ANSTEY PARK STRUCTURE PLAN

AMENDMENT No.1

SPN/0876M-1

Amendment No. 1 to the Structure Plan relates to Lots 35 and 36 being the land bound by Warnbro Sound Avenue to the west, Surf Drive to the south, Kimberly Drive (extension) to the north and established residential dwellings to the east. The area of Lots 35 and 36 is 8.0659 hectares.

The structure plan applies to land generally bounded by Warnbro Sound Avenue, Anstey Road, Mandurah Road and Kimberly Drive, Secret harbour being the area outlined in the Structure Plan Map (**Plan1**).

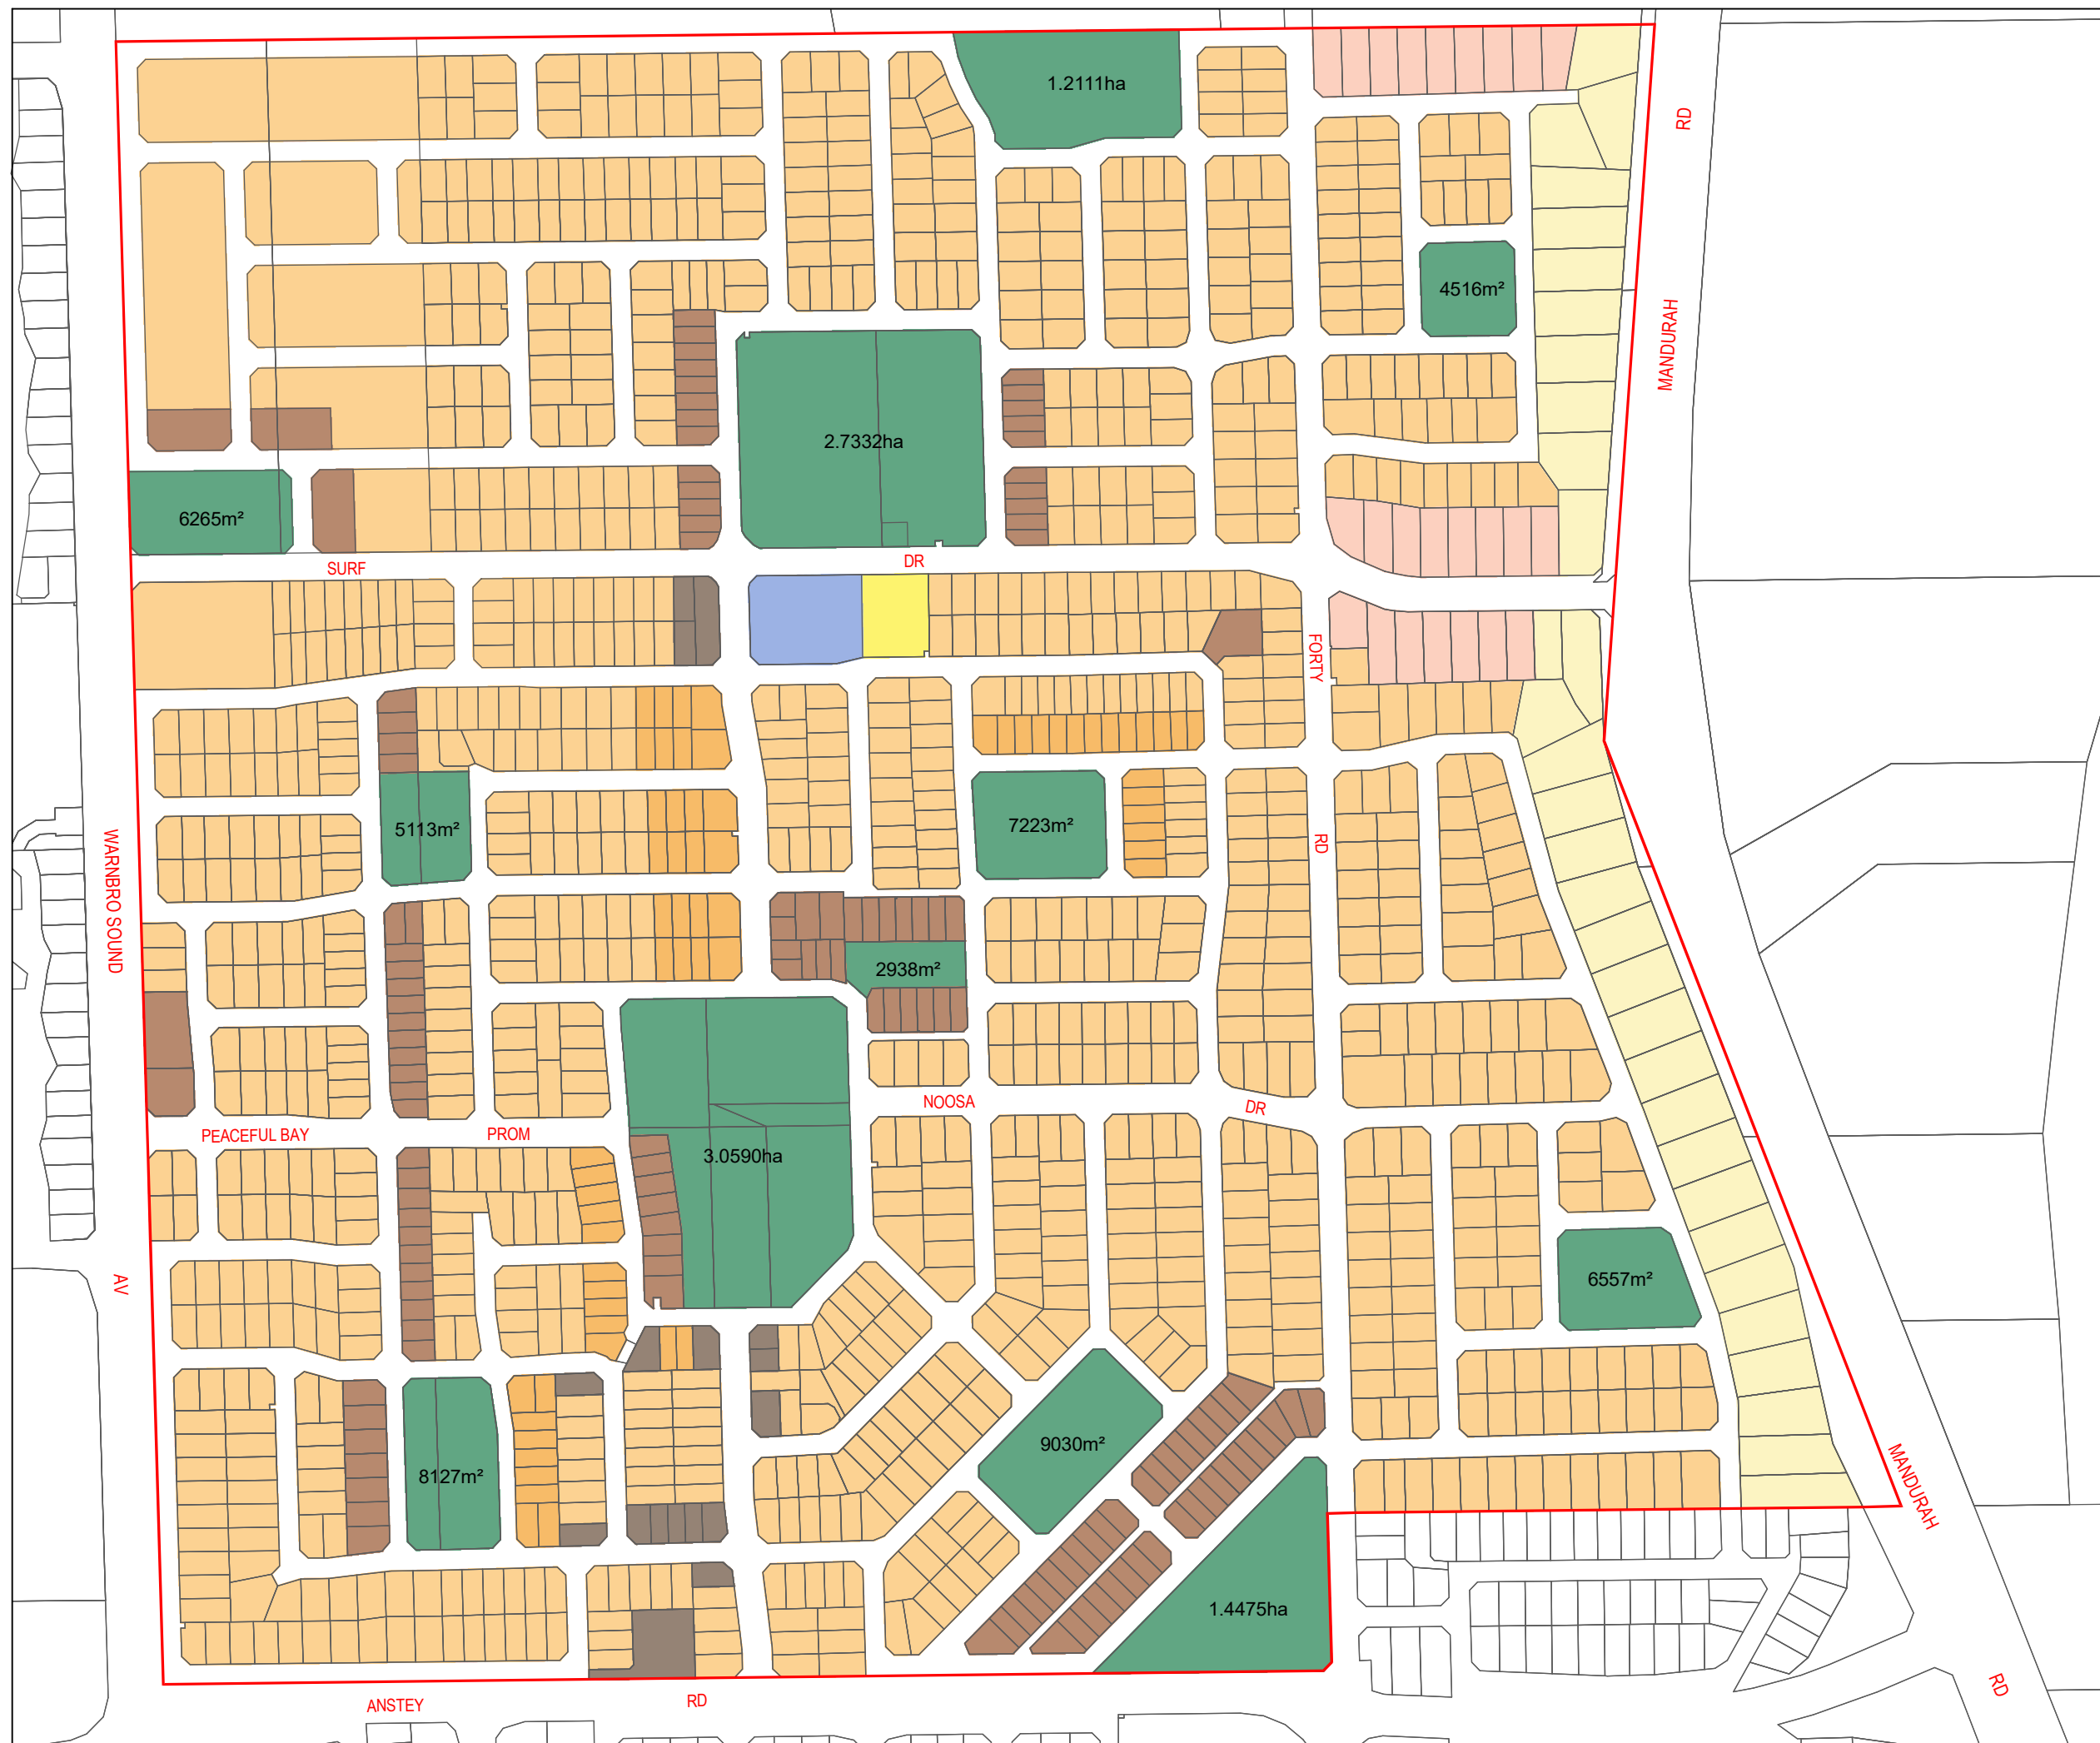
The purpose of Amendment No.1 to the Structure Plan is to:

Plan 1 designates proposed zones and reserves in the Structure Plan area.

Public open space is to be provided in accordance with Plan 1 and Table 1.

Plan 1 designates the R-Codes applicable to subdivision and development in the Structure Plan area.

Figure 2: Existing Plan for Lots 35 and 36 Surf Drive

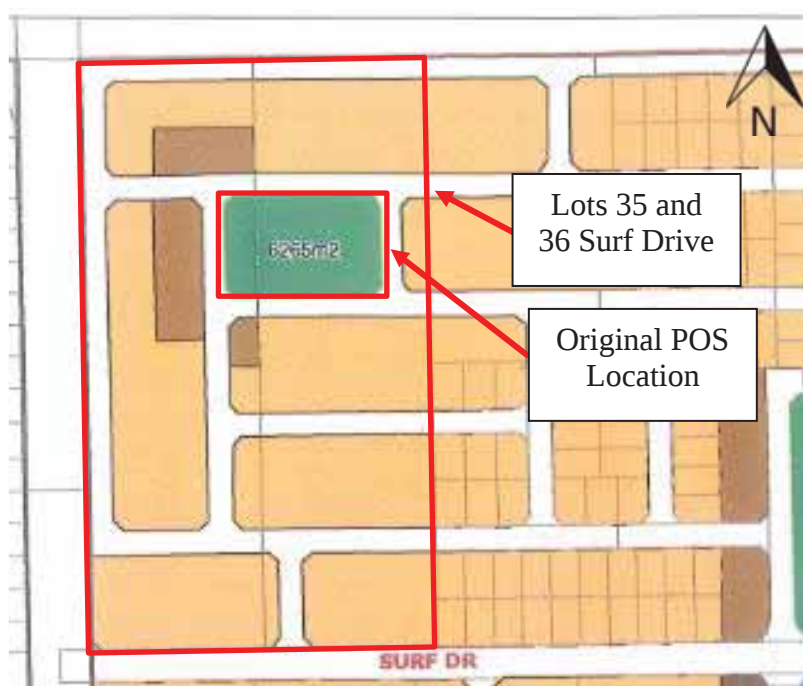
Revised planning for the subdivision of Lots 35 and 36 Surf Drive has commenced, with a review of the proposed location of the POS. It is proposed to move the location of the Public Open Space from the original location shown in Figure 2 to the proposed location shown in Figure 3.
